DRAINAGE PLAN
The following items concerning the Howard Johnson's - San Francisco
Grading and Drainage Plan are contained herein:

DRAINAGE CERTIFICATION

Howard Johnson Motel
San Francisco / I-25 NE
Albuquerque, New Mexico

Drawn by JMA Checked by JMA
Project No. P-9443.00 Date 4/18/95
AS-BUILT & CERTIFY 2/96 J.C.M.

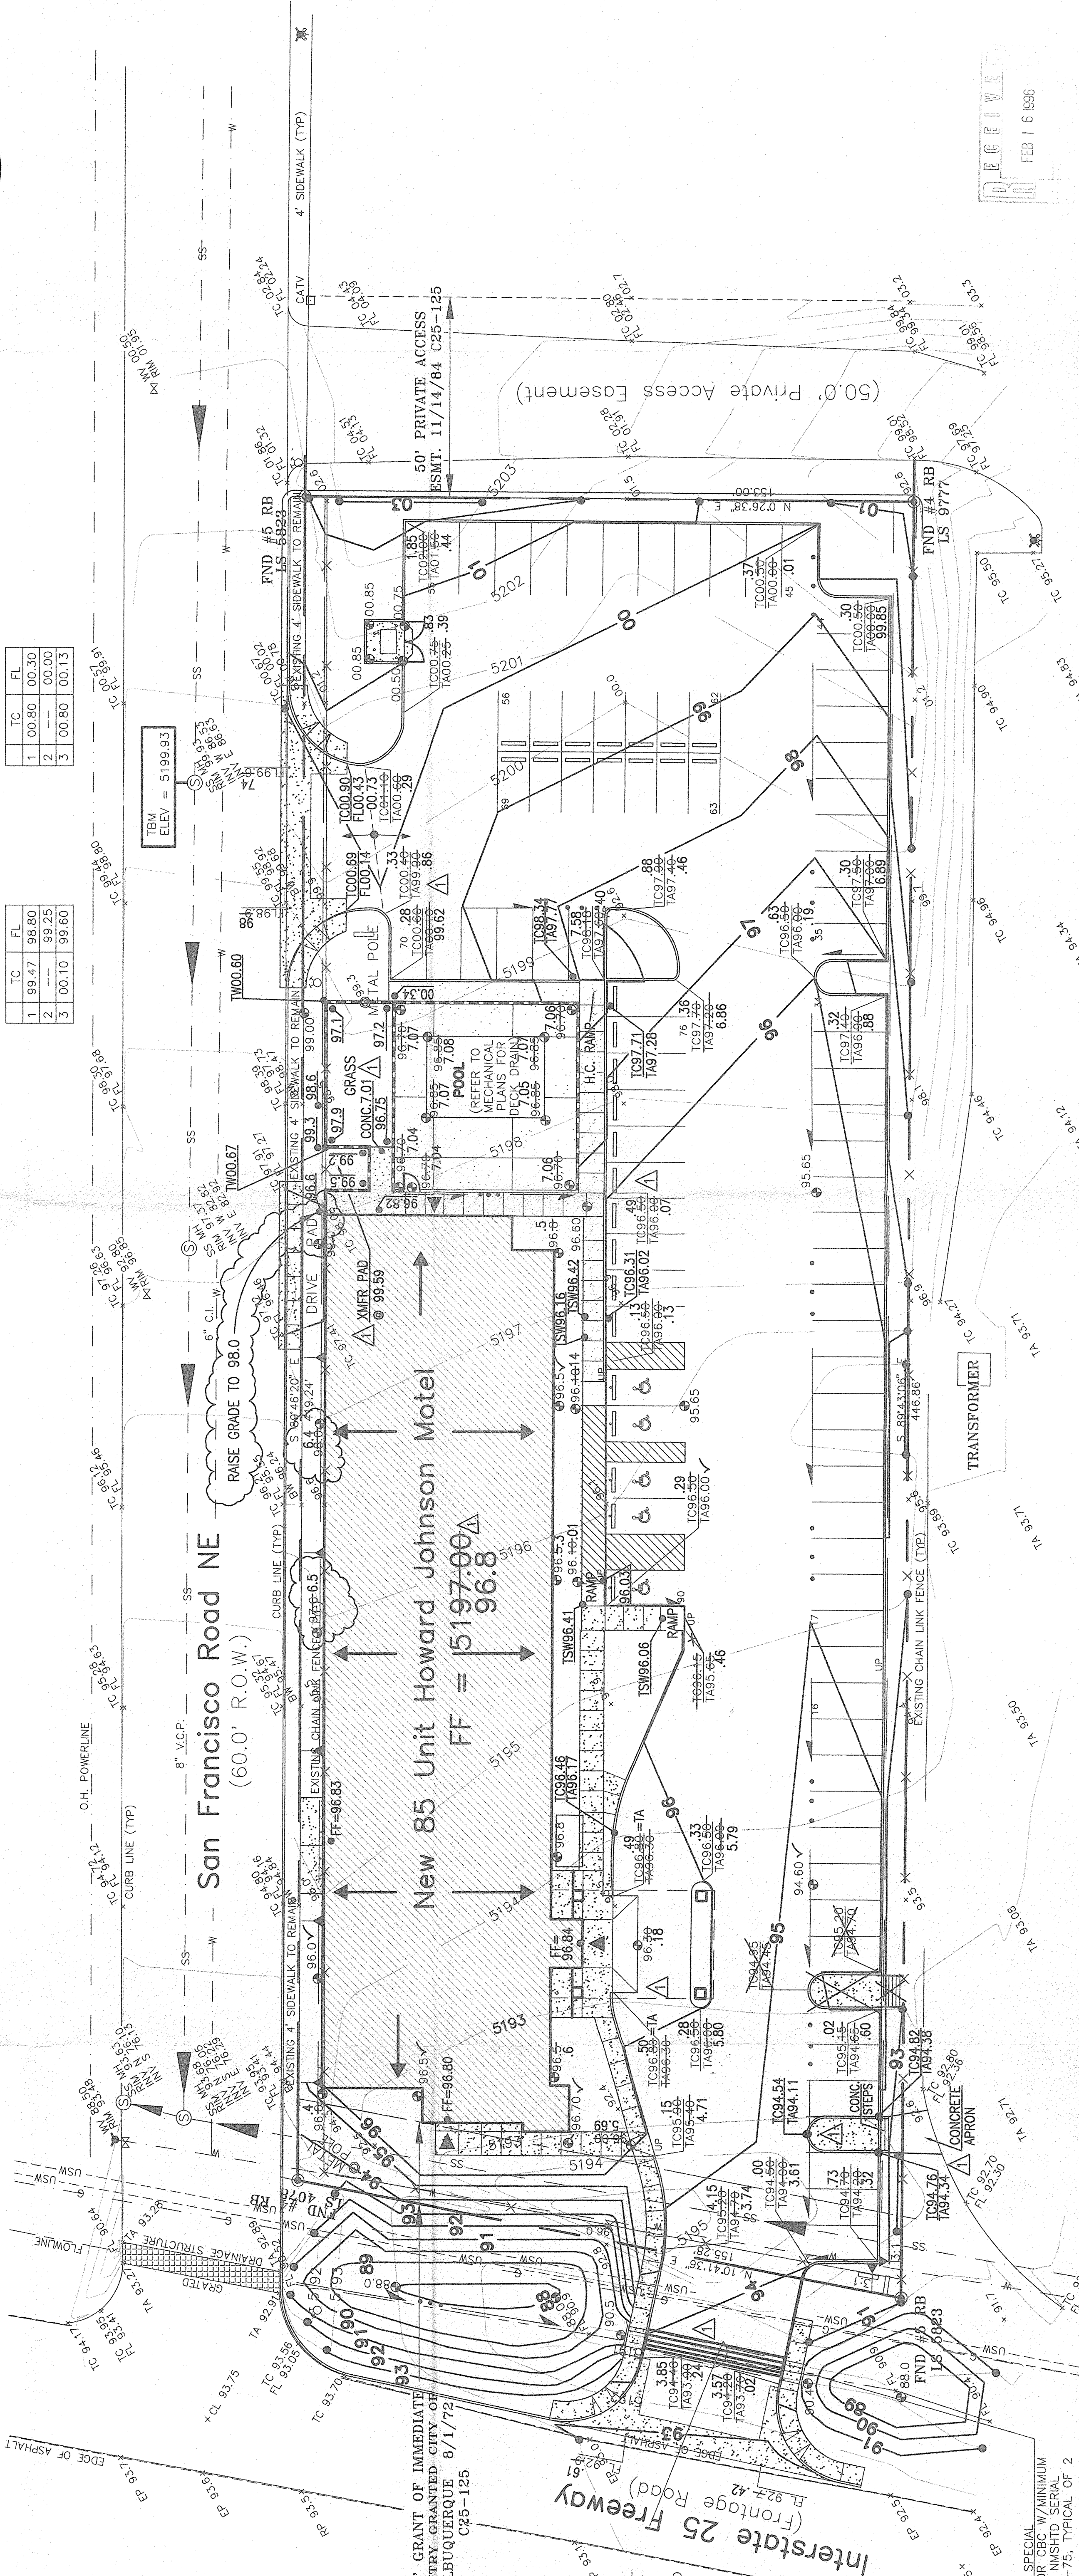
As indicated by the on-site information shown herein, the Howard
Johnson Motel, San Francisco/25 project has been constructed in
substantial conformance with the approved Grading and Drainage
Plan. However, this slight modification which was handled during
construction, does not adversely impact the drainage concepts
established by the approved plan. Corrective work is required,
which must be corrected have been "bubbled" in. This applies to three
lines in the location of underground utility. The design of the
building. Raising the grade in this area is necessary to maintain
the perimeter grade of the structure at a minimum of one foot above
the corresponding flowline of the road which is a designated flood
hazard zone. It is recommended that a Temporary Certificate of
Occupancy be issued at this time with Permanent Certificate of
Occupancy be issued at this time as the corrected work has been
accomplished and certified.
